CHEVY CHASE GARDEN PLAZA, SITE PLAN AMENDMENT NO. 81984001B

Description

COMPLETED: 4/27/2026

SITE PLAN 81984001B

DATE 04.13.2026
FIRE DEPT APPARATUS ACCESS PLAN

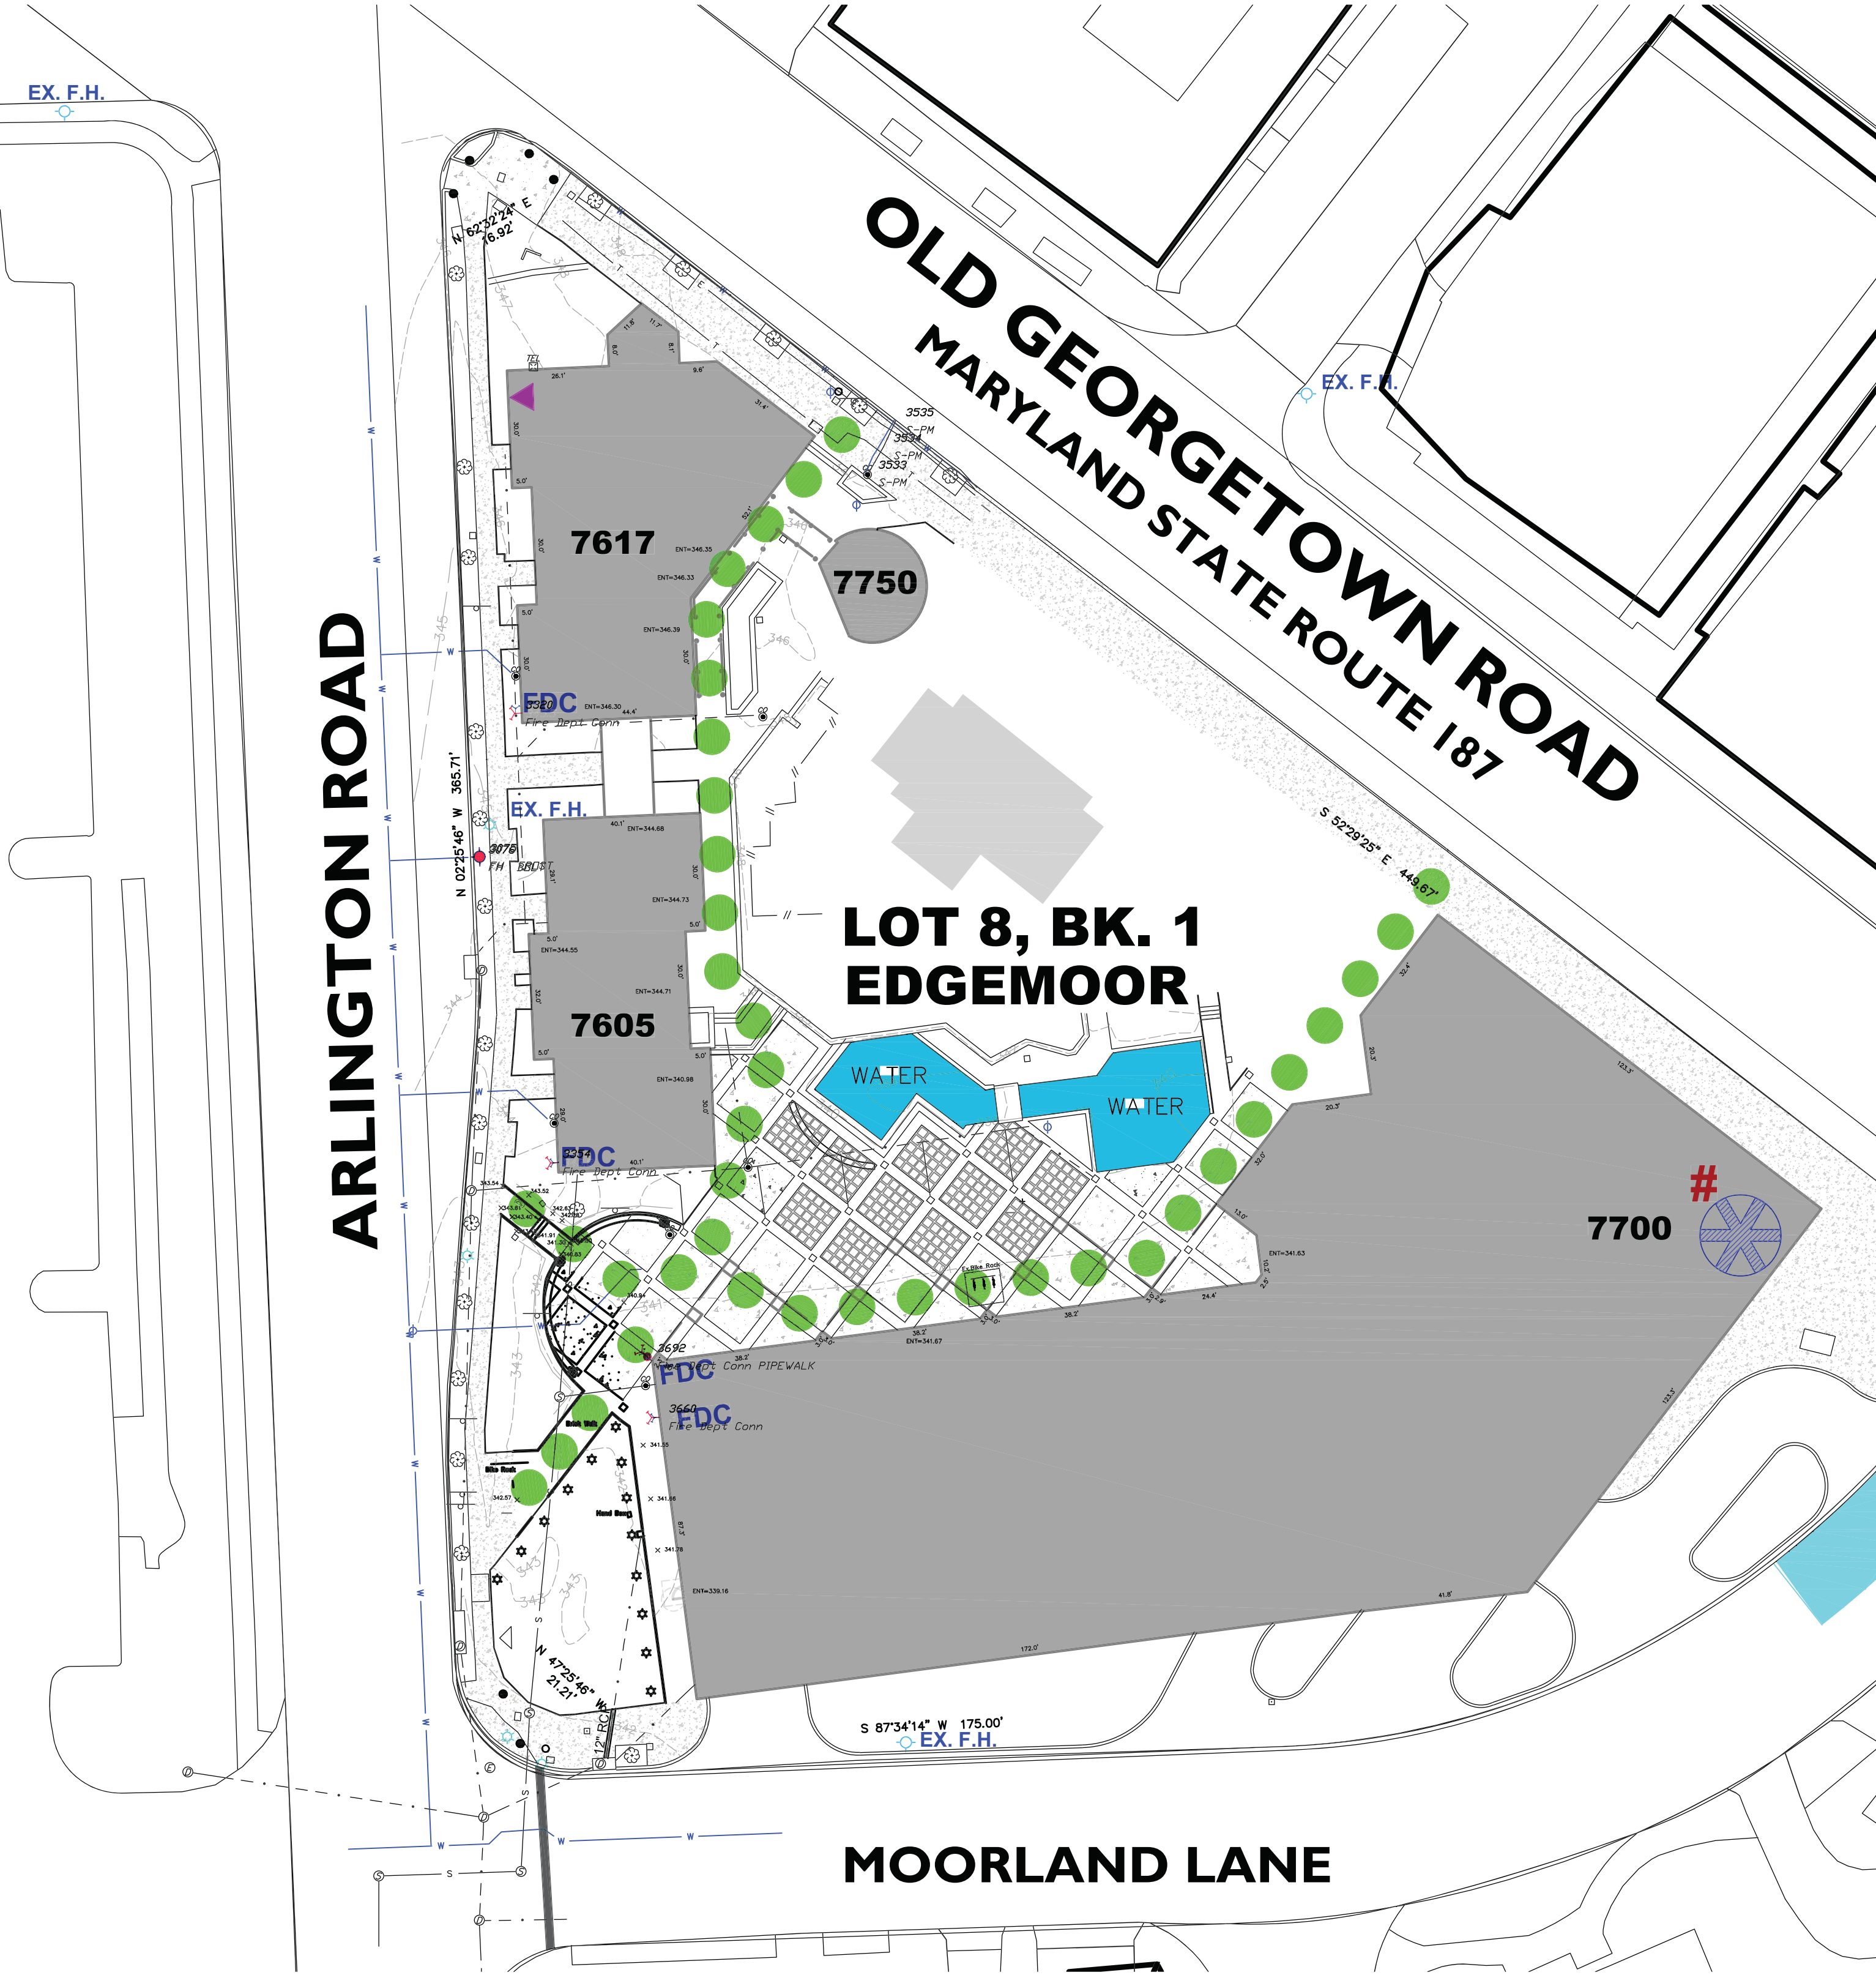
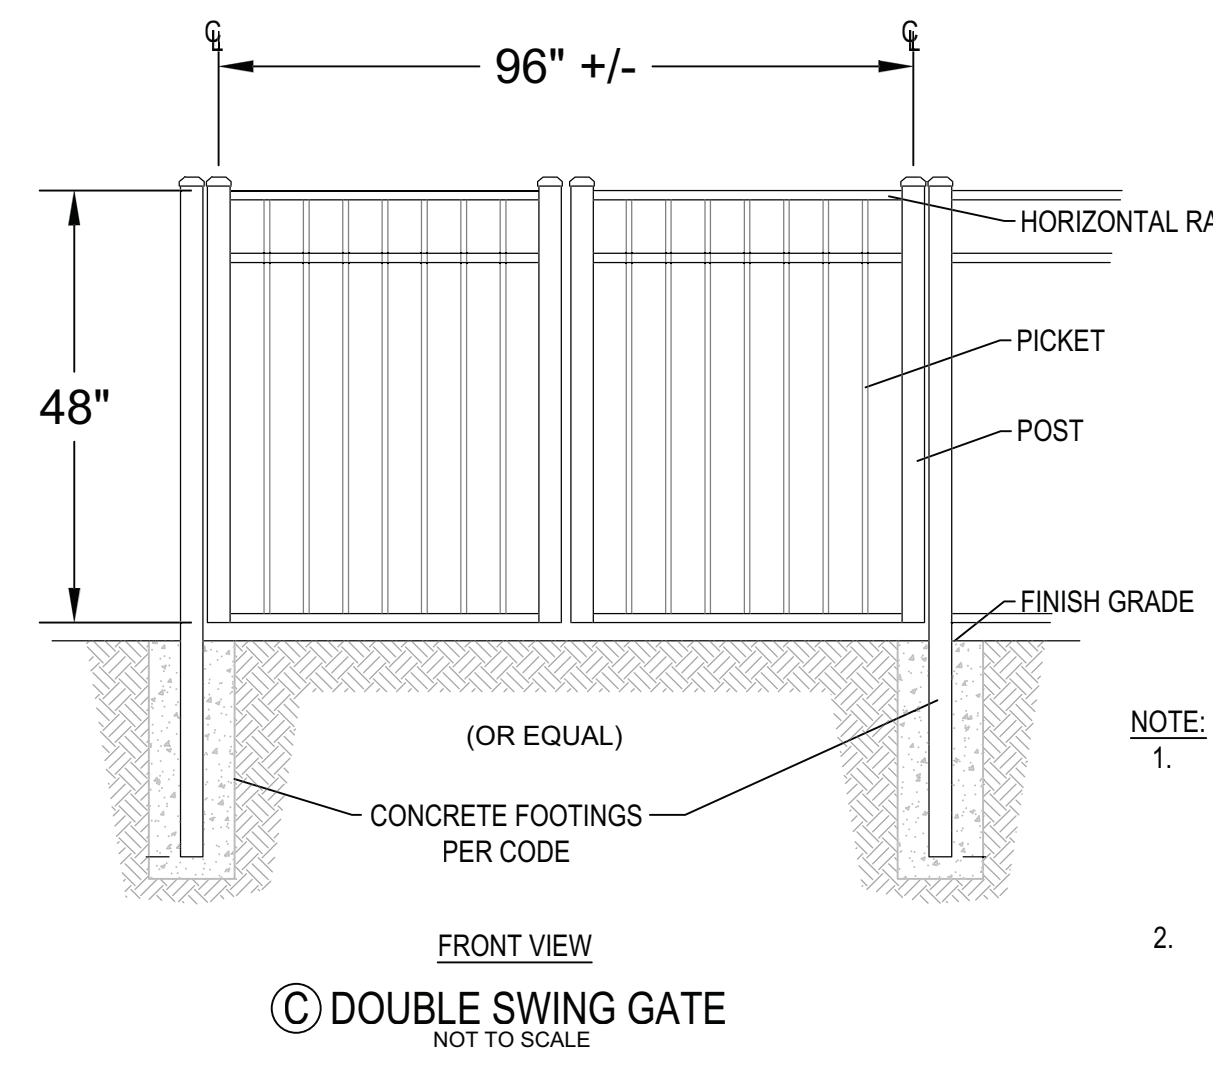
1. Review based only upon information contained on the plan submitted **13-Apr-26** .Review and approval does not cover unsatisfactory installation resulting from errors, omissions, or failure to clearly indicate conditions on this plan.
2. Correction of unsatisfactory installation will be required upon inspection and service of notice of violation to a party responsible for the property.

***** 4/13/2026 New daycare fence installation: Final FDC sign placement to be determined by life safety inspector in the field *****

BOTH PROPOSED 8'-DOUBLE SWING GATE LOCATIONS TO BE FITTED W/ KNOX BOX FOR EMERGENCY ACCESS.

FIRE ACCESS TO BE MAINTAINED THROUGH THE PLAY AREA AT ALL TIMES.

NEW FDC SIGN TO BE RE-MOUNTED AT 60 INCHES ABOVE GRADE.

FIGURE 2

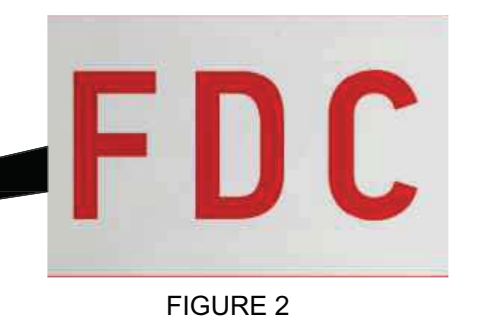
- FDC SIGN NOTES:
1. EXISTING FDC SIGNAGE (FIGURE 2) TO BE RE-MOUNTED TO BUILDING FACE AT 60 INCHES ABOVE GRADE. (SEE FIGURE 1 FOR LOCATION)
 2. DISTANCE FROM DOOR TO OPERATIONAL BAY (52") IS AN EXISTING CONDITION. BUILDING WAS CONSTRUCTED IN 1988 PRIOR TO FIRE DEPARTMENT APPARATUS ACCESS BEING ROUTINELY REVIEWED.
 3. MINIMUM LETTER SIZE = 6 INCHES
